AUS920010751US1

D. AMENDMENTS TO THE DRAWINGS

FIG. 4

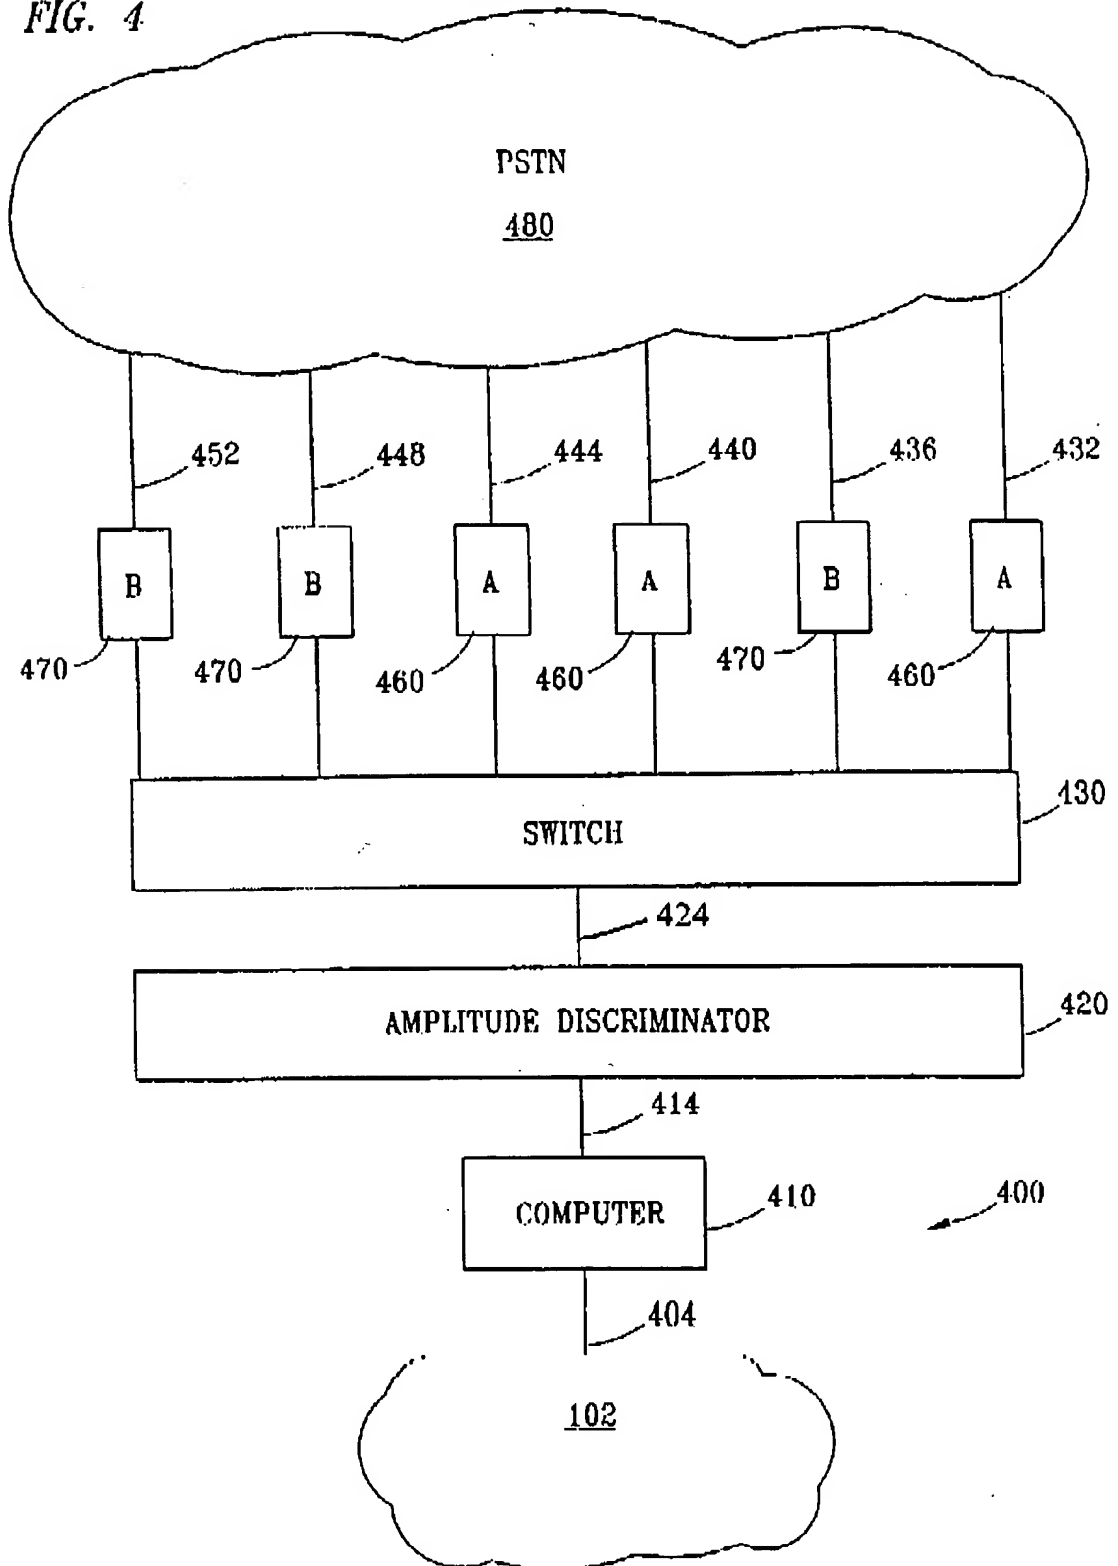
Sheet 3/15, FIG. 4 has been amended to add the numeral 424 to the line connecting switch 430 and amplitude discriminator 420. On page 8, lines 22- page 9, line 1, the specification states "Amplitude discriminator 420 is connected to switch 430 by line 424. The numeral 424 was inadvertently left off the original drawings, and a substitute drawing is provided attached to this response.

FIG. 5

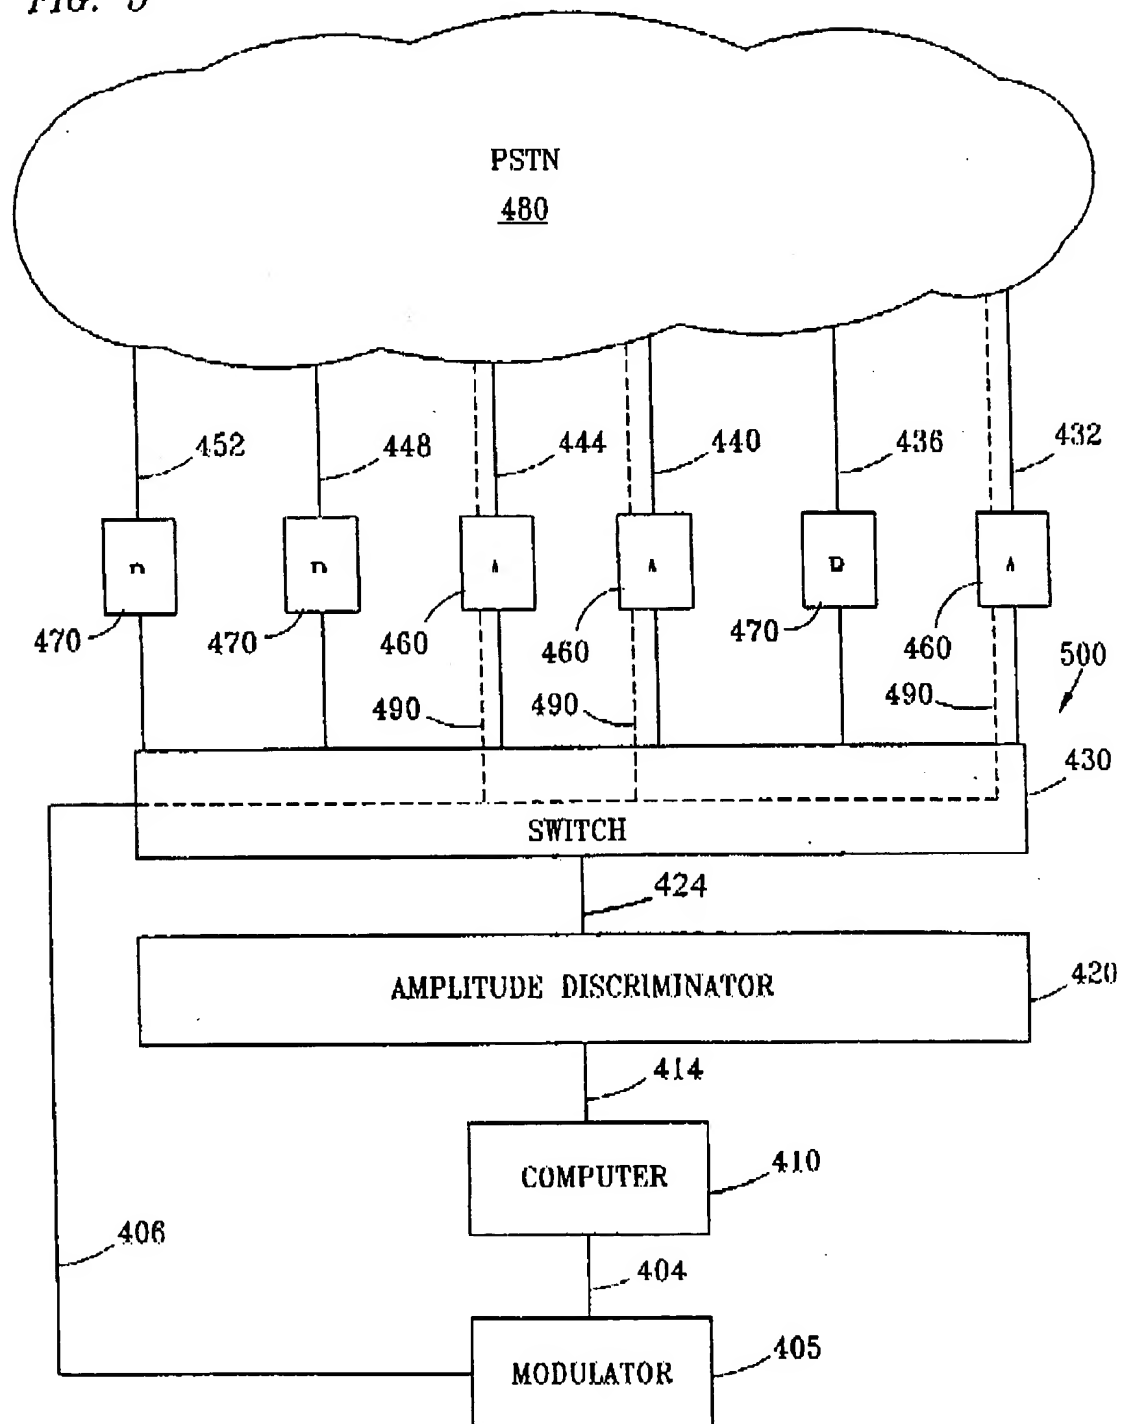
Sheet 4/5, FIG. 5 has been amended to add the numeral 424 to the line connecting switch 430 and amplitude discriminator 420. On page 9, lines 18-19, the specification states "[a]mplitude discriminator 420 is connected to switch 430 by line 424." The numeral 424 was inadvertently left off the original drawing, and a substitute drawing is provided attached to this response for correction.
